Serial No.: 09/859,706

Amendments to the Drawings

REMARKS

Fig. 3

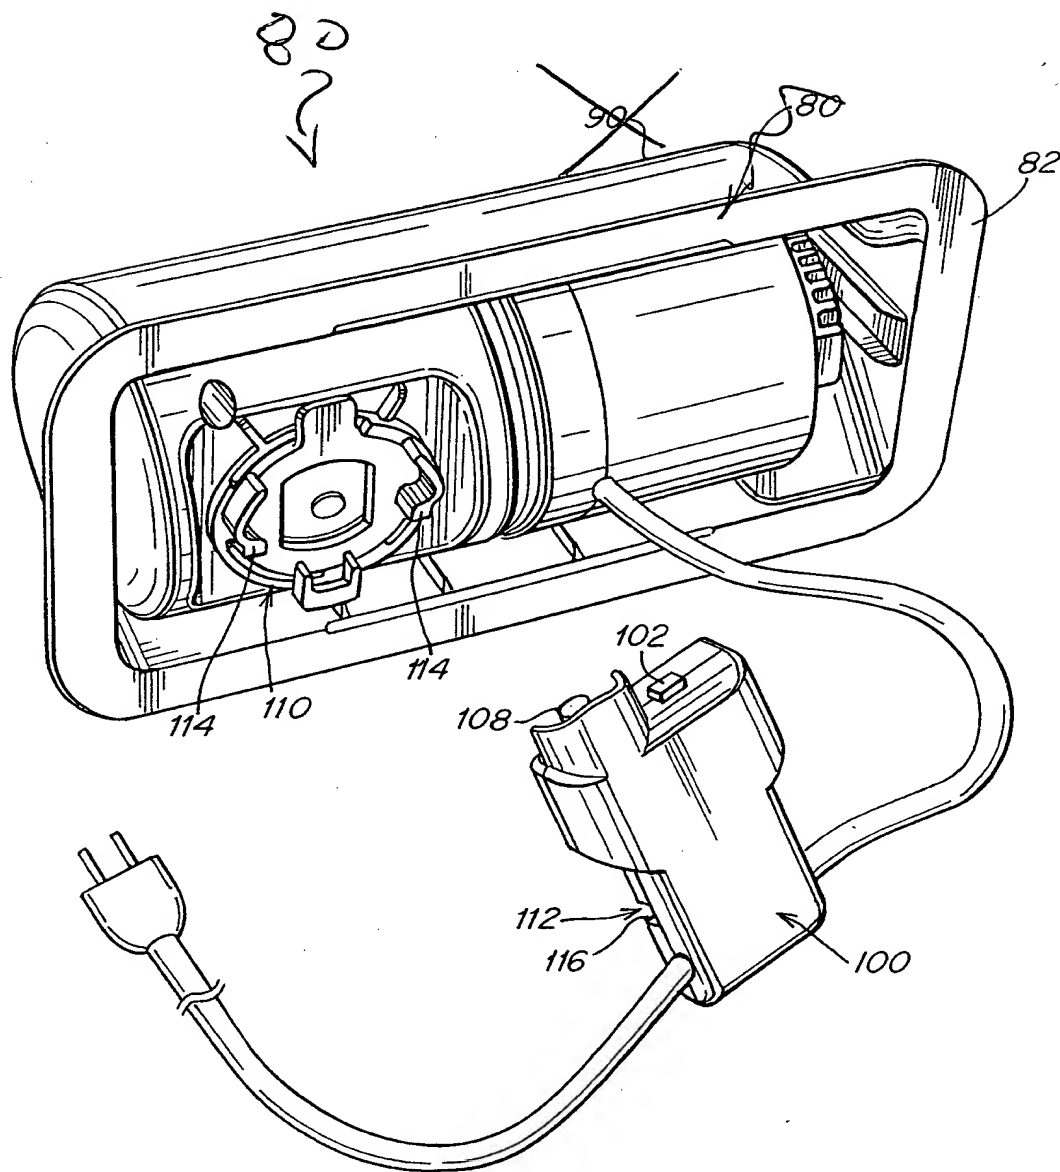
The Office Action objects to the drawings as failing to comply with 37 CFR 1.84 (p)(4) because reference character “90” has been used to indicate both the housing “90” connected to the flange “82” as shown in FIG. 3 and the housing or covering around the motor (84), impeller (86), conduit (88), solenoid (104), etc. as shown in FIG. 5. Applicant has deleted reference character 90 from FIGS. 3 and 4 of the enclosed annotated drawings so as to eliminate any confusion. It is clear from the specification that the reference character 90 refers to the housing 90 that surrounds the inner workings of the pump 81, such as the motor (84), impeller (86), conduit (88), solenoid (104), etc., and can also serve as a connection between the fluid controller 80 and the bladder 20. Accordingly, withdrawal of this objection is respectfully requested.

The Office Action also objected to the drawings asserting that the reference numerals “83” and “90” have both been used to designate “fluid impermeable wall” (see FIG. 5) and “housing” (see FIG. 3). As noted above, FIGS. 3 and 4 have been amended to eliminate to reference character “90” from these figures, as the fluid impermeable wall is designated by the reference number 83 in FIG. 5. Accordingly, the drawings have been corrected and withdrawal of this objection is respectfully requested.

As to claims 5, 6, 8, 9, and 26, the Office Action asserts that they all recite a "housing" which is confusing because the specification and drawings are not clear as to what constitutes the housing (i.e., is it the structure connected to the flange (82) as shown in FIG. 3 or is it the structure surrounding the motor (84), impeller (86), conduit (88), solenoid (104), etc. as shown in FIG. 5?). As has been discussed above, the housing 90 surrounds, for example, the motor, the impeller, the conduit, the solenoid, etc. as shown in FIG. 5 and any reference to the housing 90 in FIGS. 3 and 4 have been deleted. Thus, the drawings have been corrected and the claims are

clear as to what is a housing as is claimed in these claims. Accordingly withdrawal of this rejection is respectfully requested.
